Final recommendations of the Sunset Cliffs Traffic Study Committee of the OBPB 15May2010

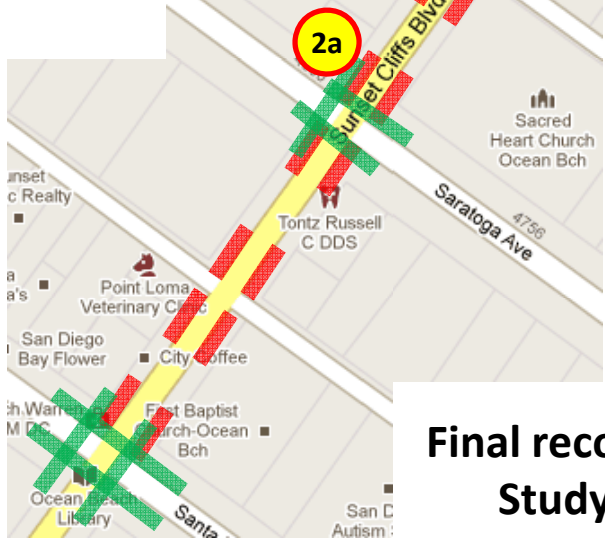
1. Extend red zones to 2 vehicle spaces at all roads and alleys (if not already)
2. Add underground interactive flashing crosswalk at Brighton
3. Add painted crosswalk at Cape May/Long Branch/Muir.
4. Extend red zone on North/West side of SSC from corner of Brighton to first curb cut

2a. Change Saratoga flasher to a “push to flash” crosswalk

5. Add interactive speed sign for southbound traffic
6. Add interactive speed sign for northbound traffic
7. Reduce speed limit on SSC prior to W Pt Loma to 35mph
8. Install rumble strips or dots on Sunset Cliffs north of West Point Loma in straight lane only
9. Install OB friendly “slow it down” sign
